Executive Director's Recommendation

Commission Meeting: September 7, 2017

PROJECT New Guard Booth and Fence Augmentation Nebraska Avenue Complex, United States Department of Homeland Security 3801 Nebraska Avenue, NW Washington, DC	NCPC FILE NUMBER 7903
SUBMITTED BY United States General Services Administration	NCPC MAP FILE NUMBER 10.04(38.00)44593
REVIEW AUTHORITY Federal Projects in the District per 40 U.S.C. § 8722(b)(1) and (d)	APPLICANT'S REQUEST Approval of preliminary and final site development plans
	PROPOSED ACTION Approve preliminary site development plans
	ACTION ITEM TYPE Open Session

Proposed Fence Augmentation – Existing Conditions and Elevation

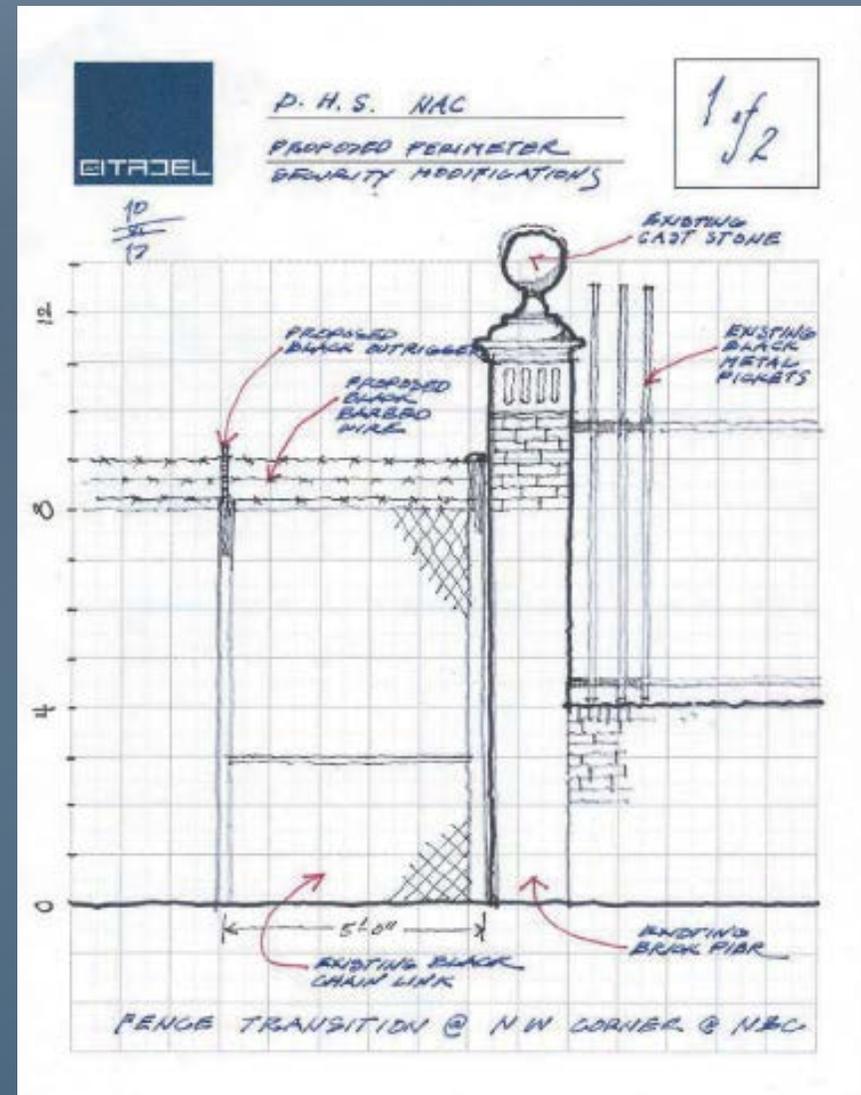
View east from Nebraska Avenue at NBC4 entry - NCPD recommendation to add landscaping to minimize the visual impact of chain link fence and barbed wire

Proposed Fence Augmentation – Existing Conditions and Section

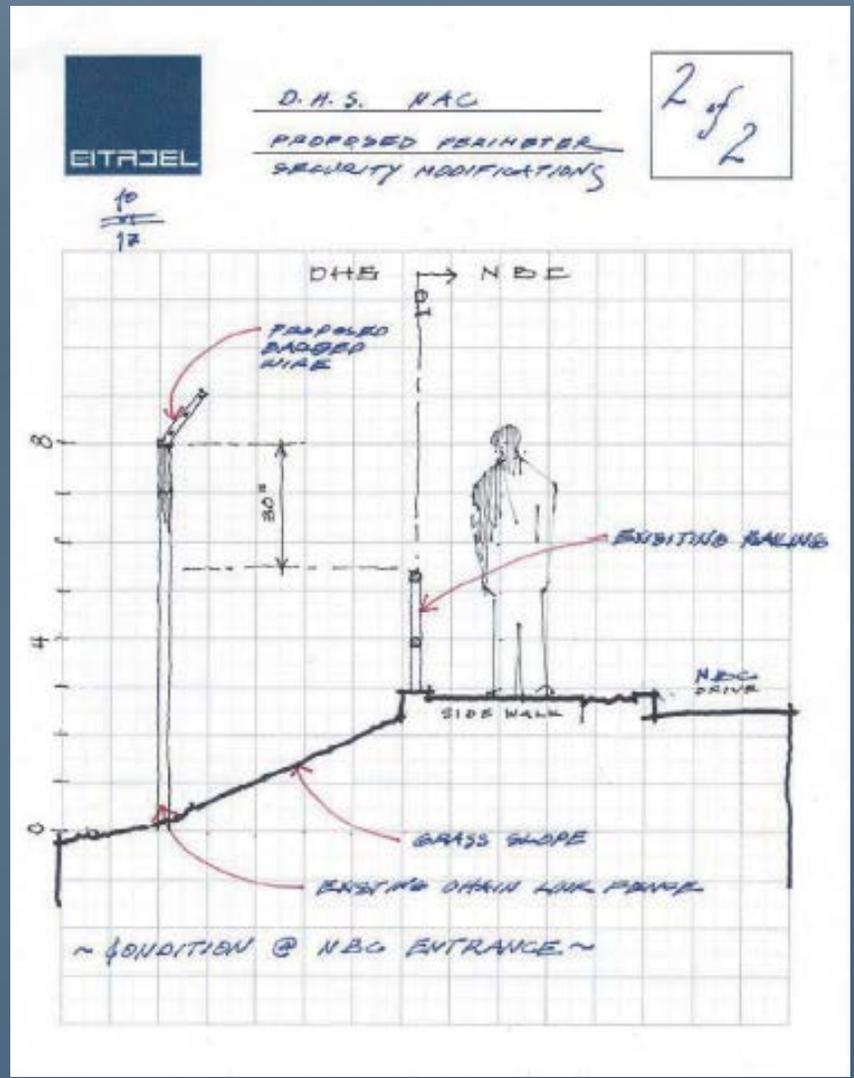
View north to Nebraska Avenue from interior NW corner of campus - NCPC recommendation to add landscaping to minimize the visual impact of chain link fence and barbed wire
